Memorandum

City of Lawrence

RE: CPA-13-00067: Horizon 2020 Chapter 6 and Revised Southern Development Plan and Z-13-00071: RM12 to CR: Menards

{Option 2: Proposed Development Request with Pad Sites}

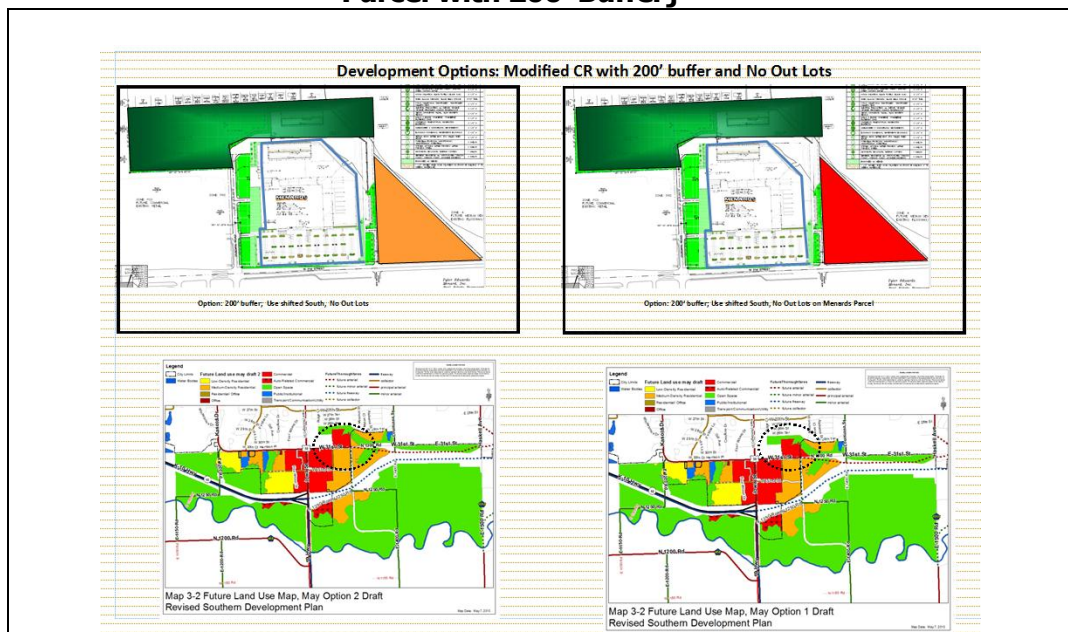
The following graphics depict the Menards project as proposed both with and without the inclusion of commercial land to the east (Snodgrass property). An option for consideration is approving the proposed CR request and amending the Revised Southern Development Plan to extend the commercial area to the east property line of the Menards site and retain medium density residential land use east of the subject property. If approved, the Commission may want to consider expanding the commercial designation to the east incorporating the western portion of the Snodgrass property as shown below. The existing floodplain is designated on the Revised Southern Development Plan as open space. The floodplain/floodway would be a clear terminating feature of commercial use along the north side of W. 31st Street.

{Option 3a and 3b: Proposed Development Request without Pad Sites on Menards Parcel with 200' Buffer}

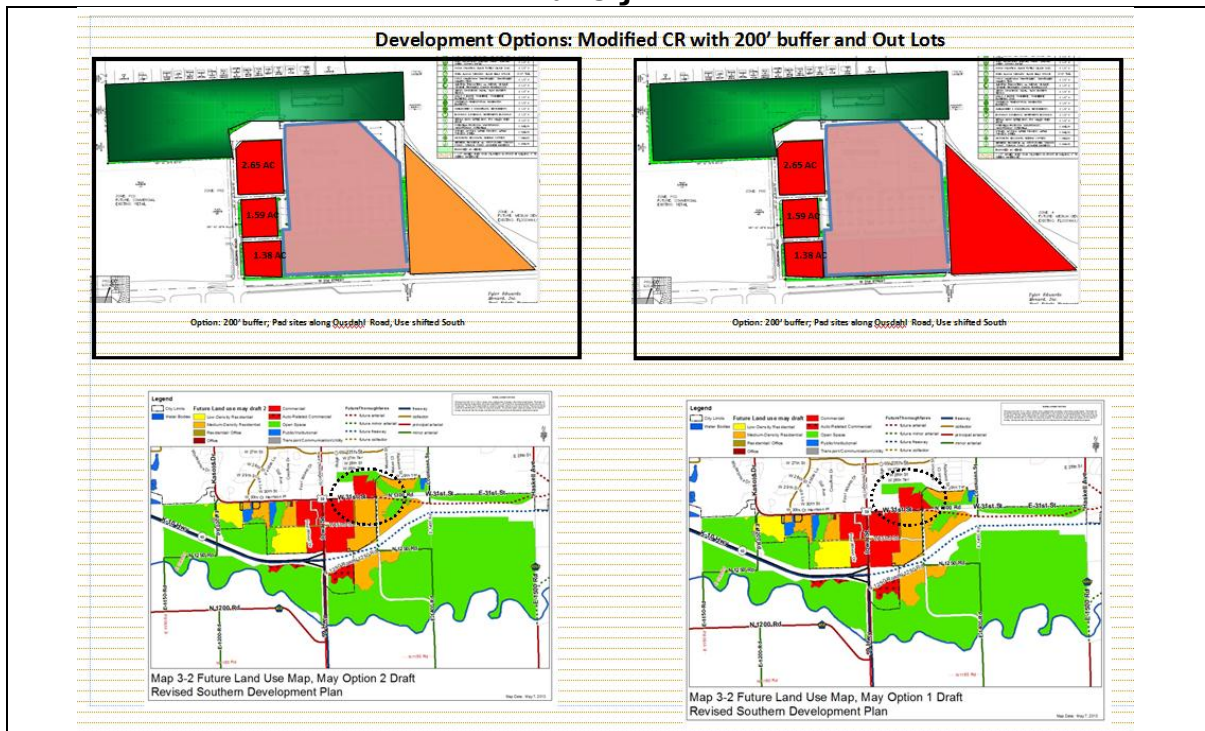
1. Deny the applications.
2. Approve applications as proposed by applicant.
3. Approve applications with conditions:
 - a. Require a 200' buffer along the north property line, limit the development to a single use big box tenant [move building and parking lot forward to frame 31st Street] and exclude out lots.
 - b. Require a 200' buffer, single use big box tenant [move building and parking lot forward to frame 31st Street], and designate adjacent property to the east for future commercial development.
 - c. Require a 200' buffer, permitting a reduction in the size of out lots on the Menards property, and designate the adjacent property to the east for future commercial development in the Revised Southern Development Plan.

1. Land Use Patterns (Refer to attachments Map 3-2 Revised Southern Development Plan Option 1 Draft and Option 2 Draft)

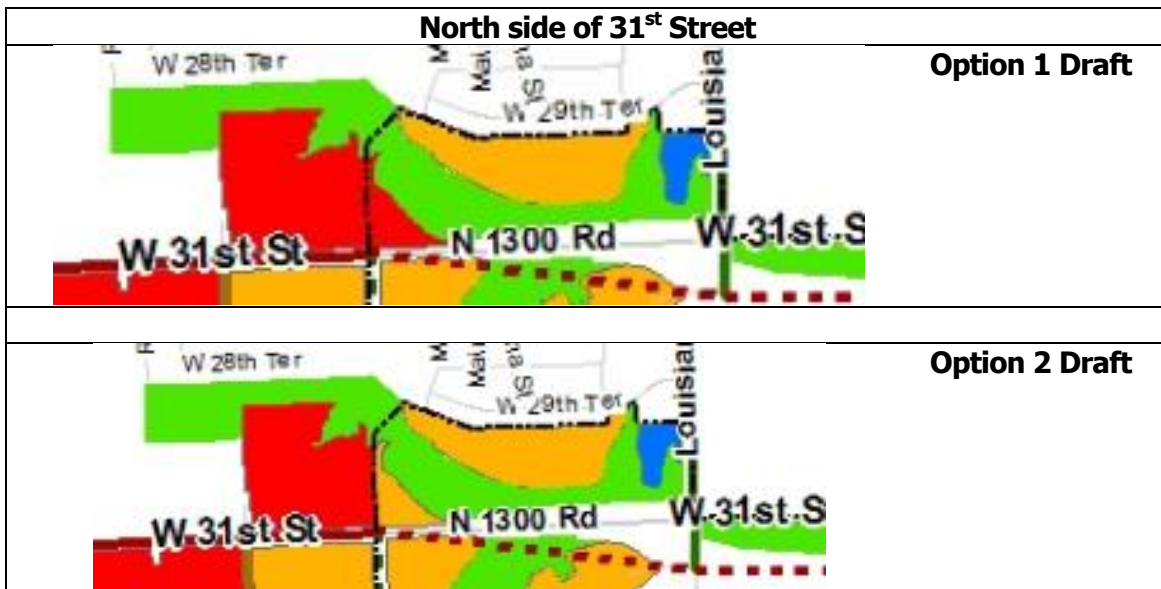
The city is actively engaged in acquiring the eastern 5.6 acres of the Snodgrass property for future utility improvements. Utility improvements are typically platted and zoned GPI (General Public and Institutional) District reflecting the public nature of the land use. This known land use will preclude commercial development at the northwest corner of 31st Street and Louisiana Street. The attachments show land use along the north side of 31st Street updated with a future utility pump station located on the northwest corner of Louisiana Street and 31st Street. **(Blue Map Area)**

The area abutting the Indian Hills neighborhood continues to be reflected as medium density residential in both Option 1 and Option 2. This area is paired with a text discussion in the plan that defines the land use recommendation to not more than 8 dwelling units per acre for density and that building type should be limited to detached, duplex, triplex and rowhouses (Page 24, Revised Southern Development Plan). **(Orange Map Area)**

Both options of Map 3-2 show the Menards property as commercial with designated open space along the north property line. The open space shown in this plan reflects the current floodplain boundaries within the study area and recommended open spaces areas as a transitional land use between high intensity and lower intensity land uses. **(Green Map Area)**

Commercial use is shown for the Menards application as an option noted in the beginning of this memo. The two maps depict that commercial area with and without the addition of the western portion of the Snodgrass property included. **(Red Map Area)**

c. Floodplain and Stormwater Requirements

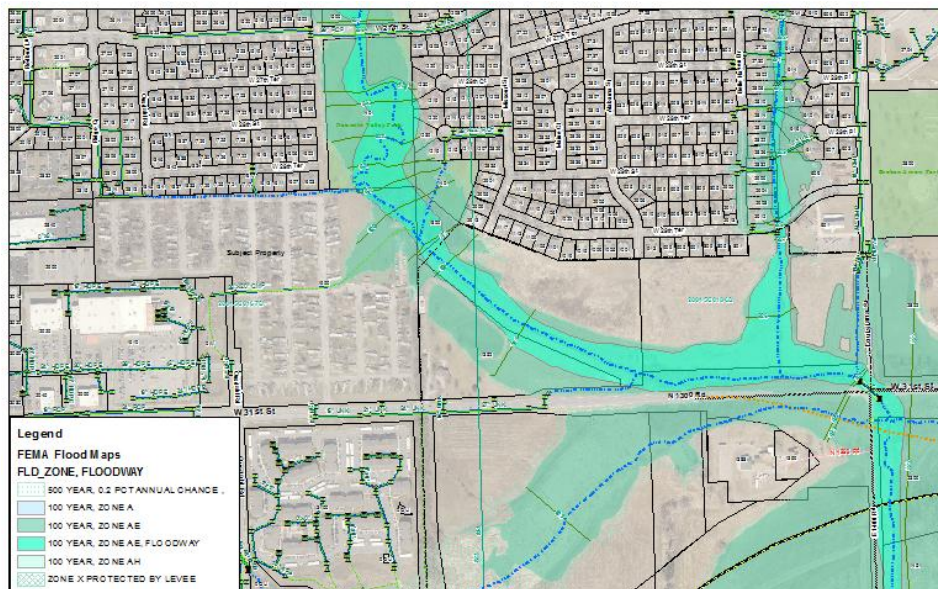
This area is encumbered by regulatory floodplain of Naismith Creek. The creek flows to the south east crossing the northeast corner of the subject property and diagonally through the abutting property to the east. A tributary of Naismith Creek is located along the north property line of the subject property. This tributary is not within the regulatory floodplain. The creek depth along the north property line is not large enough to offset additional impervious surface that will result from development. The provision of a wider riparian area (in the form of a dedicated green space area) will provide an opportunity to alleviate existing and potential drainage issues in this area.

The applicant has provided concept plans to staff along with very preliminary grading and stormwater information. The specific development project has not been submitted for official floodplain or site plan review at this time. Based on information contained in the concept plan staff has identified several issues with regard to floodplain regulations that are not compliant with the City's Development Code, one being that the floodplain regulations prohibit fill within the setback areas.

The floodplain regulations also prohibit storage of materials within the floodplain. This will have an impact on the site design that will be considered with the submission of a subdivision plat and site plan for the site. In addition, the applicant will need to submit an Hydrologic & Hydraulic study for review that shows no change in the water surface elevation.

The conceptual plan includes a large area along the northwest portion of the property to be excavated for fill to raise the site above the base flood elevation and to further elevate the site closer to the existing street grade. To achieve an elevated pad site, fill, borrowed from within the

site, will result in a deep pond area that will not drain and will be subject to anaerobic activity that results in attracting mosquitos and that can be a safety hazard depending on final design.

The depth and configuration of this borrow pit area should be designed to maximize the stormwater improvements needed in the area. By making the area wider and shallower, the capacity for stormwater is increased and the overall drainage system in an area prone to flooding is improved.
